DOCKETED	
Docket Number:	18-IRP-01
Project Title:	Integrated Resource Plan
TN #:	229804
Document Title:	Updated - Staff Paper Review of Modesto Irrigation District 2019 Integrated Resource Plan Filing
Description:	***This document supersedes TN#229778***
Filer:	Courtney Wagner
Organization:	California Energy Commission
Submitter Role:	Commission Staff
Submission Date:	9/20/2019 10:56:32 AM
Docketed Date:	9/20/2019

Review of Modesto Irrigation District 2019 Integrated Resource Plan Filing

June 2019 | CEC-200-2019-008

Figure 1: Modesto and Energy Commission Energy Forecasts 2018-2030 (GWh)

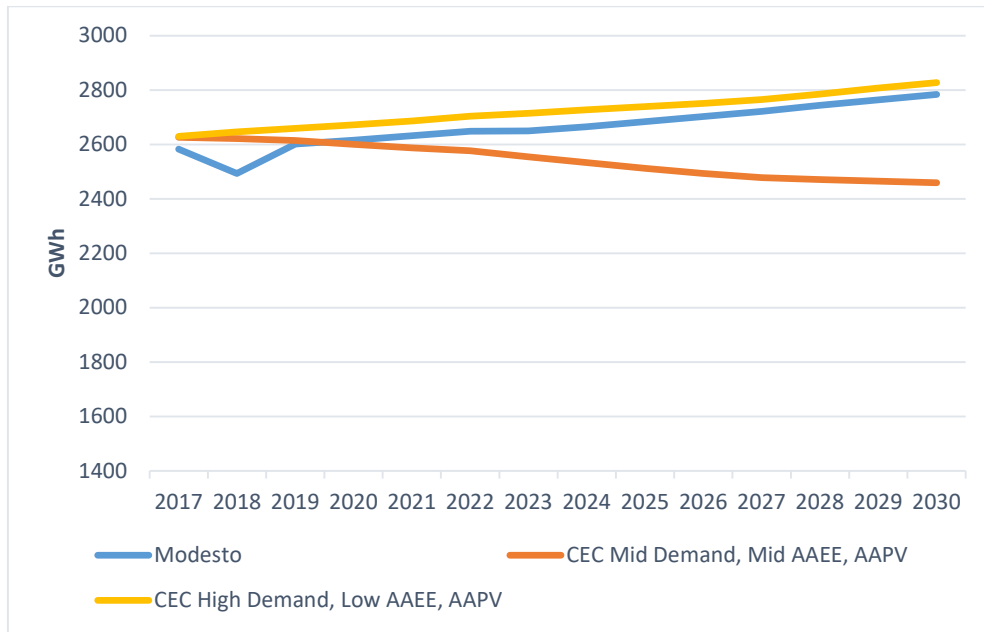
Modesto's net energy demand forecast shows an annual growth of 0.9 percent from 2018 to 2030. The annual energy growth rate was -0.2 percent from 2008 to 2017. The energy forecast growth is mostly due to the regional economic recovery after 2014. The Modesto forecast is comparable to the Energy Commission's forecast, falling within the range of the mid demand case and the high demand case, as shown in **Figure 1**.⁶

Figure 2: Modesto and Energy Commission Peak Forecasts 2018–2030 (MW)

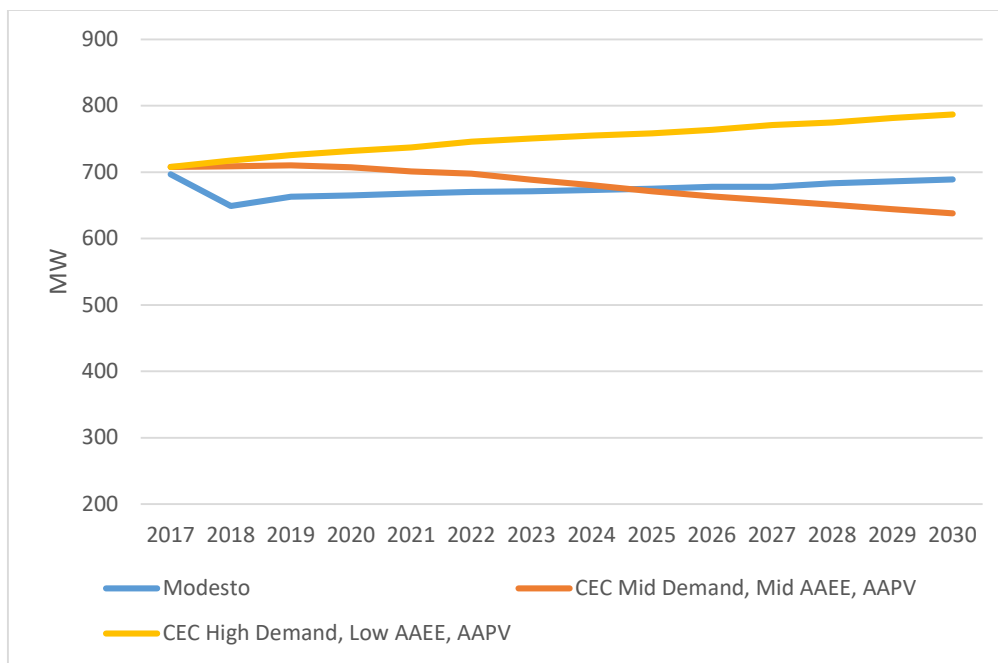
The Modesto peak demand forecast has an annual growth of 0.4 percent from 2018 to 2030. The annual peak demand growth from 2008 to 2017 was low at 0.8 percent, largely because of slower annual growth in demographic variables. The peak forecast is in the range of Energy Commission’s mid demand and high demand cases, as shown in Figure 2.

The differences between Modesto's and the Energy Commission's forecasts could be because of differences in modeling methods, since the Energy Commission's forecasts uses an end-use forecast, and Modesto uses an econometric forecast. Another potential source of the difference between Modesto and the Energy Commission forecast could be how additional achievable energy efficiency (AAEE) and additional achievable solar photovoltaic are calculated and incorporated into the models.

Figure 5: Modesto Portfolio Comparison for 2019 and 2030

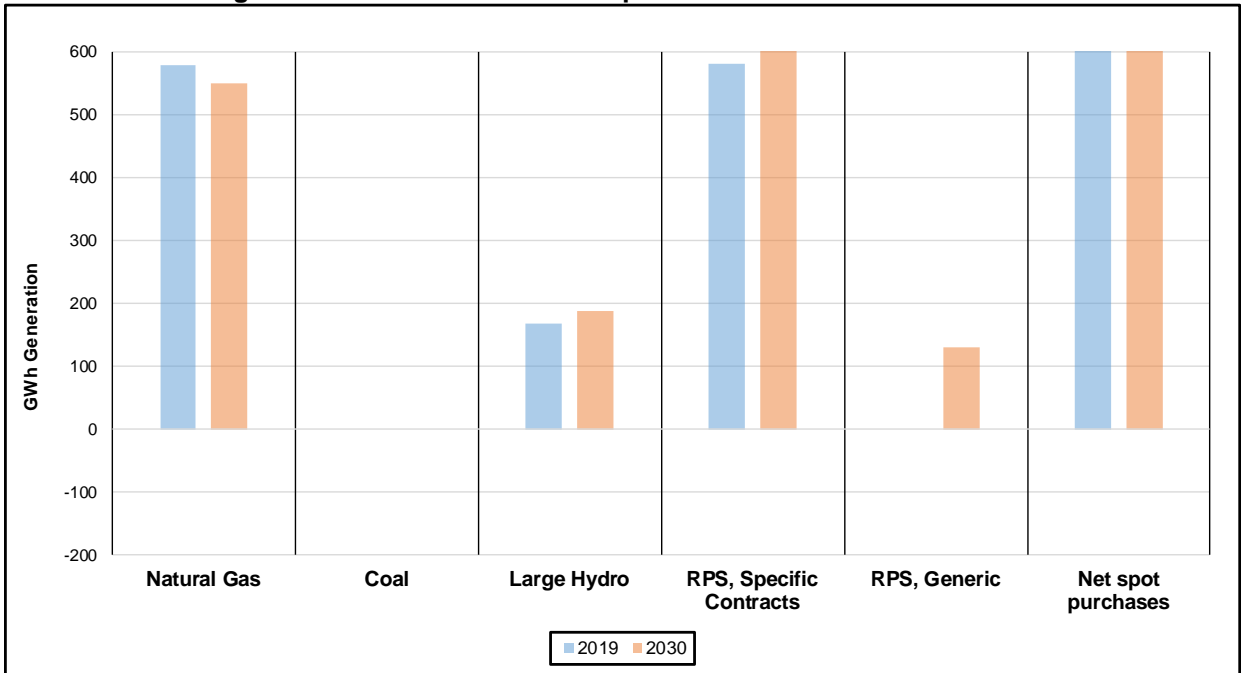
PUC Section 9621(d)(1)(D) requires that POU's address the procurement of a diversified portfolio of resources consisting of both short-term and long-term electricity and electricity-related and demand-response products. Based on staff's review of Modesto's existing resources, its portfolio analysis, and the selection of resource additions in its IRP, staff concludes that the utility has fulfilled this requirement. **Figure 5** shows a comparison of the energy mix by resource in Modesto's preferred portfolio in 2019 and 2030.
